R19AI

DATE: March 24, 2022
TO: Blue Bird Owners
Subject: RECALL R19AI – Service Brake Switch Bracket Deformation on Driver Control Module

SUBJECT: RECALL R19AI – Service Brake Switch Bracket Deformation on Driver Control Module

R19AI – Ford Service Brake Switch Bracket Deformation

Figure 1

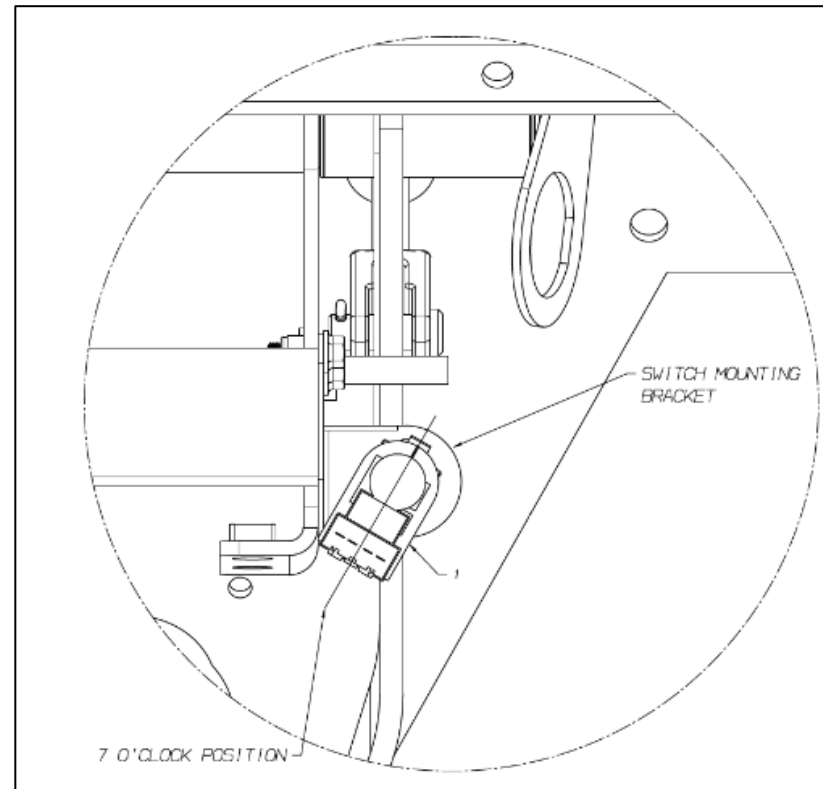
1. Locate service brake switch in front of driver's area, above brake pedal arm.
2. Disconnect the electrical connector from the service brake switch.
3. Rotate the service brake switch clockwise to the 7 o'clock position, and remove. (Figure 1)
The switch will not be reused, it should be marked as bad and discarded.

Figure 2

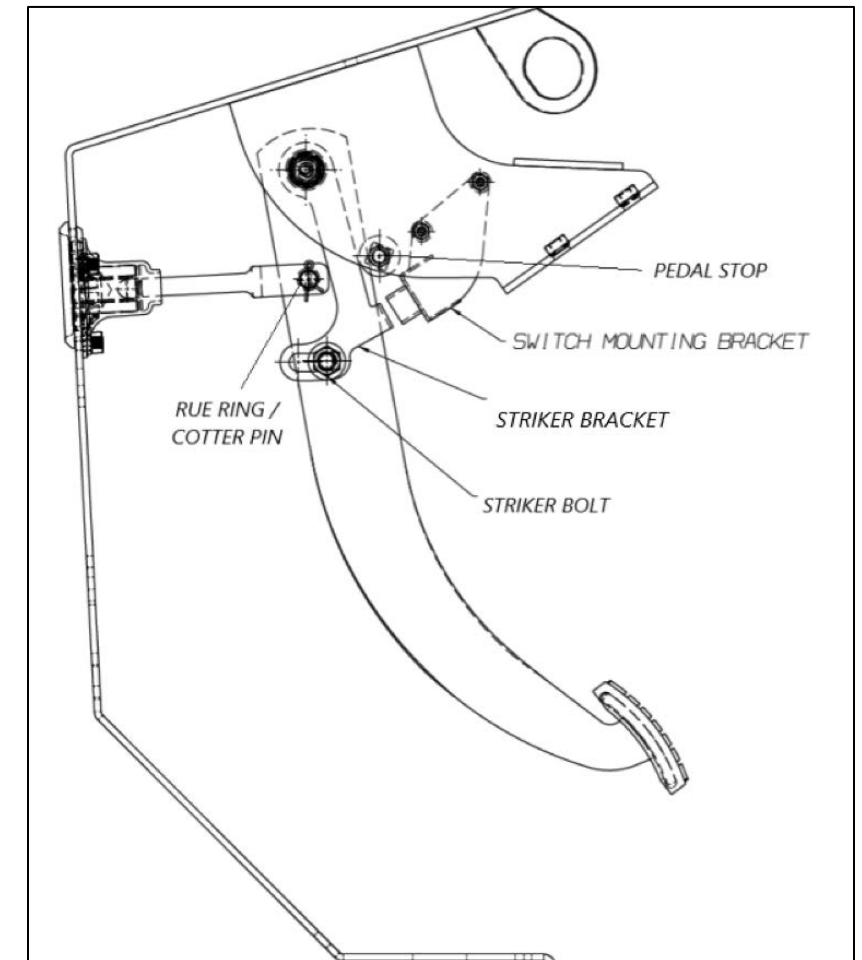
4. Remove the two fasteners mounting the switch mounting bracket to the steering column housing. Retain the mounting fasteners. *The switch bracket will not be reused, it should be discarded.* (Figure 2 and 3)

5. Remove and retain the E-Clip, nut and washer from brake pedal pivot shaft (Figure 3)
6. Remove the rue ring (or cotter key) and clevis pin from yoke/brake pedal (Figure 2)

7. If necessary, back off the pedal stop (threaded bolt) from steering column bracket to allow free motion of the brake pedal. (Figure 2)
8. Rotate brake pedal fore and aft, as necessary, while sliding to the right until removed from pivot shaft. (Figure 3)

Figure 3

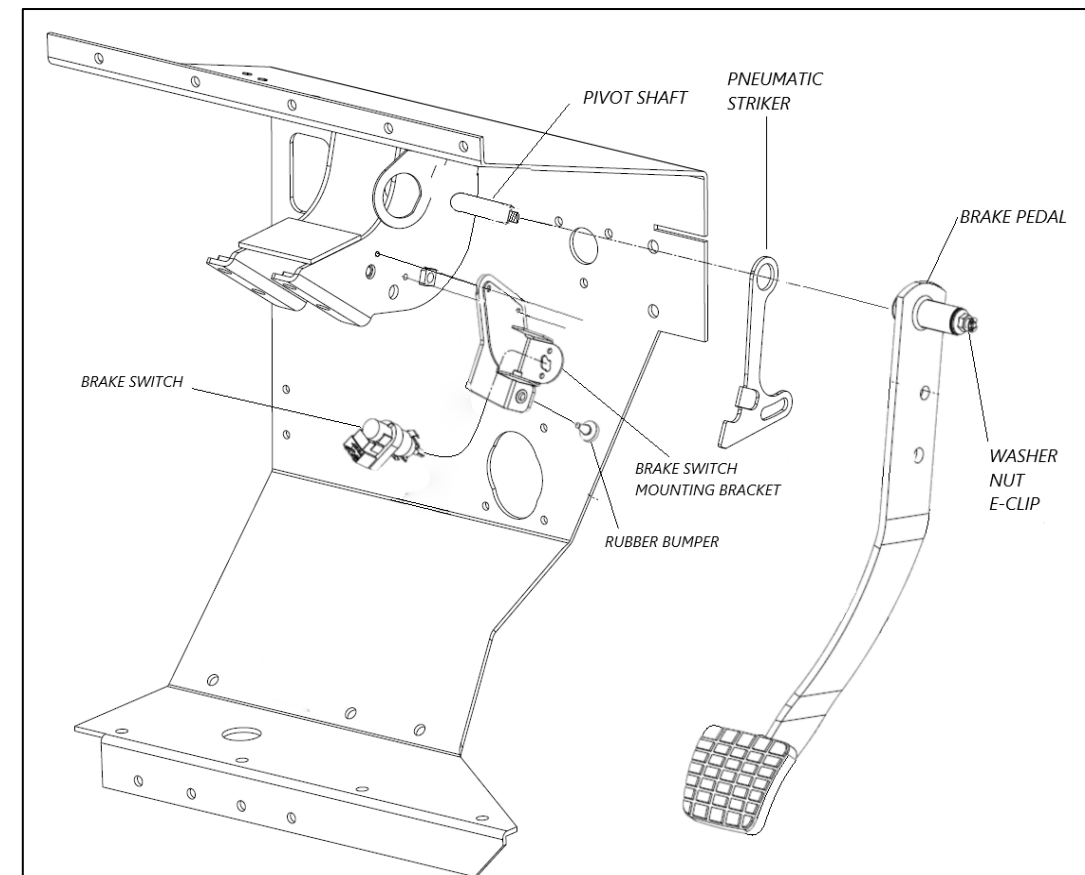
9. Remove striker bracket from brake pedal assembly. (Figure 3) Retain the 1/2" striker nut, bolt and washers, as they will be reused.
The striker bracket will not be reused, it should be discarded.
